TVA NUCLEAR QUALITY ASSURANCE (NQA) PLAN (TVA-NQA-PLN89-A) – ANNUAL UPDATE

TENNESSEE VALLEY AUTHORITY NUCLEAR QUALITY ASSURANCE PLAN (TVA-NQA-PLN89-A), REVISION 14 DESCRIPTION OF CHANGES

**Tennessee Valley Authority
Nuclear Quality Assurance Plan
Revision 14**

APPENDIX G
Page 1 of 1

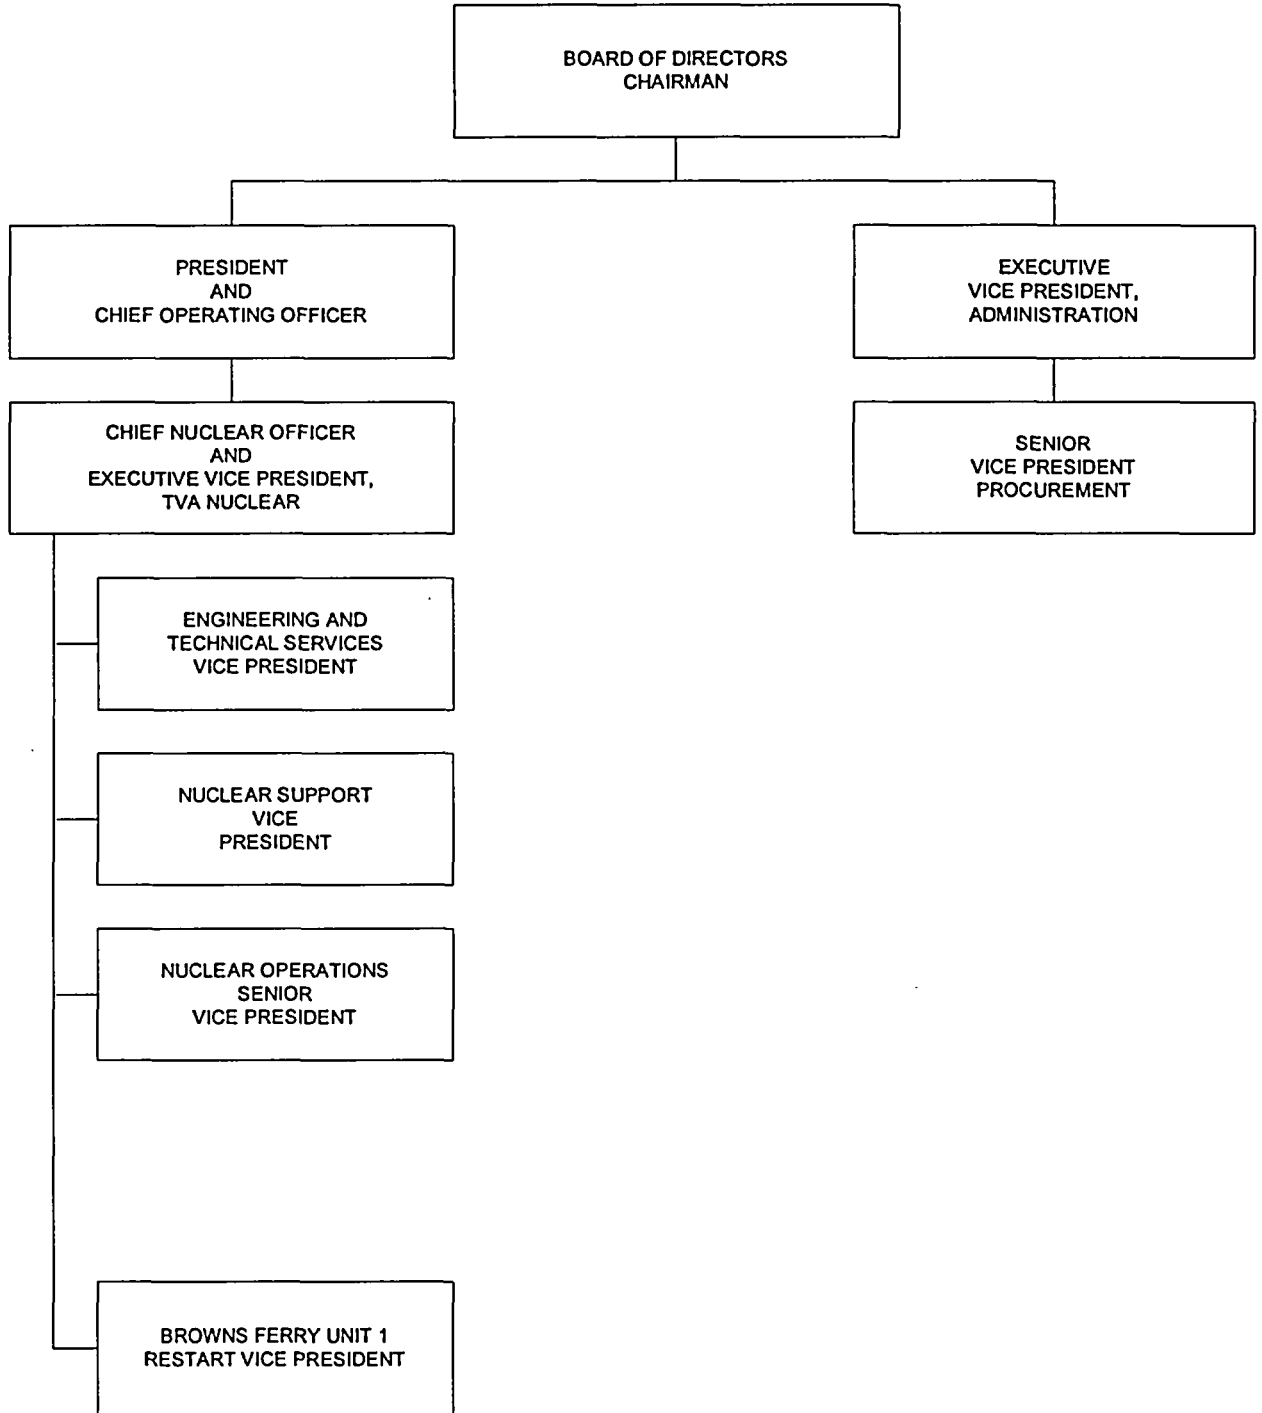
Add a circle for the “ISFSI Facility.”

Clarify/enhance ISFSI requirements to implement 10CFR72.

APPENDIX H
Page 2 of 2

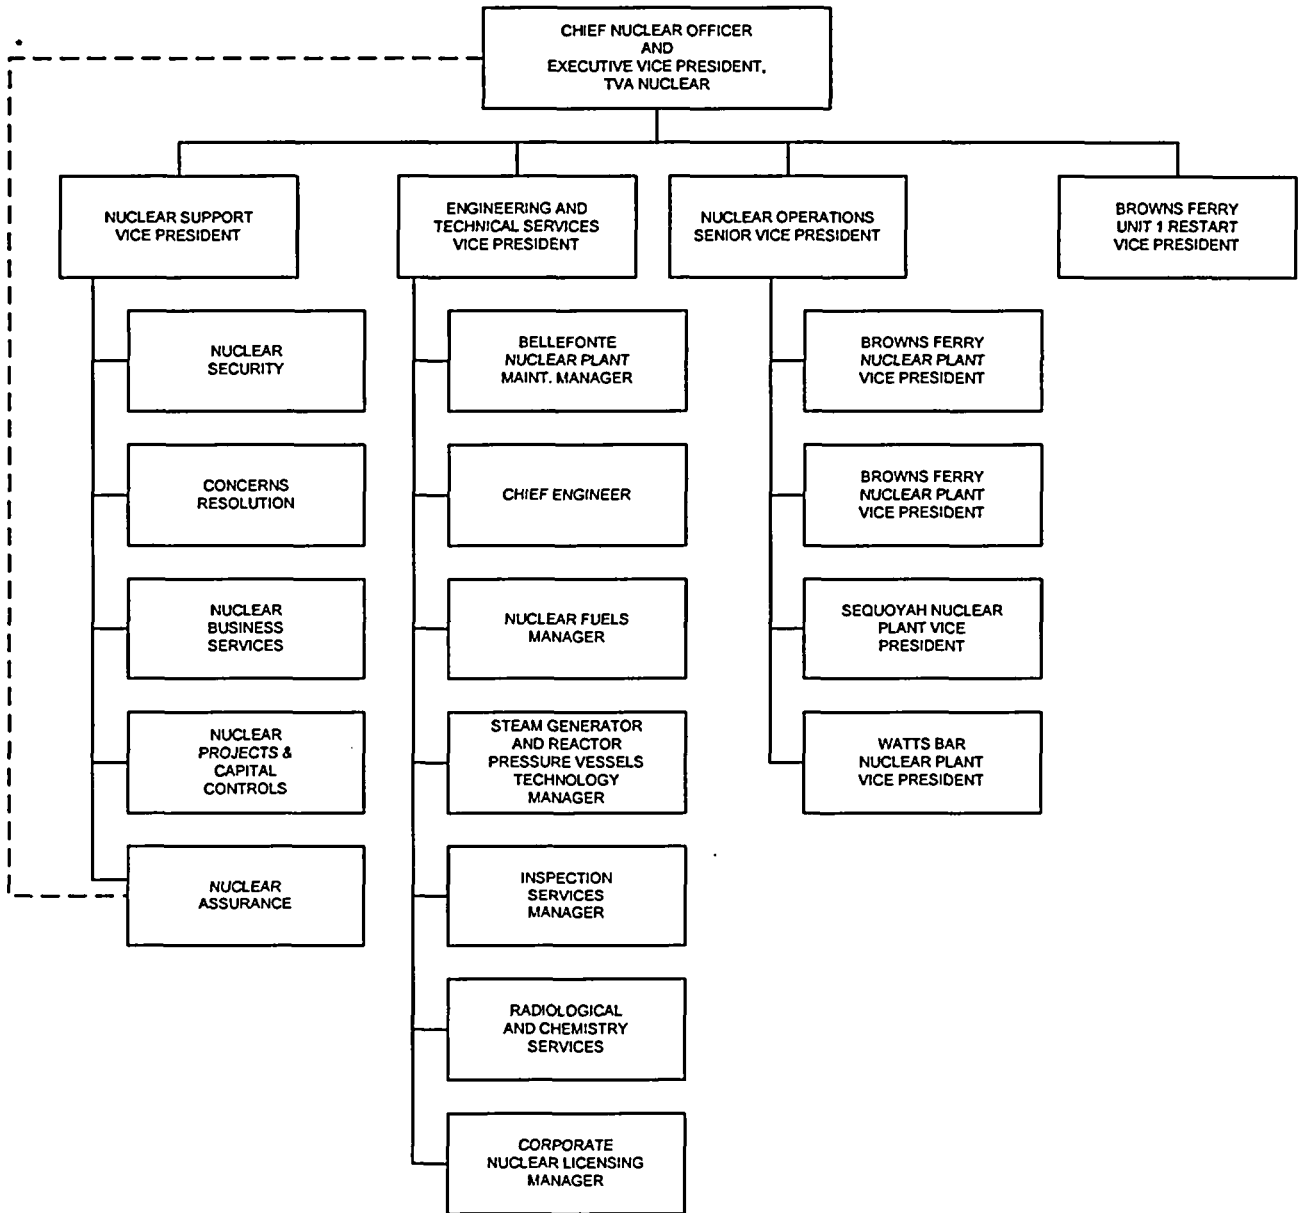
Added “Nuclear Assurance” to the Organization Chart indicating reporting to the Nuclear Support Vice President. Added a “dotted line” from Nuclear Assurance to the Chief Nuclear Officer and Executive Vice President, TVA Nuclear, and included a note with the “dotted line” stating the following:

*Independent reporting to the Chief Nuclear Officer and Executive Vice President, TVA Nuclear, on quality status and issues.
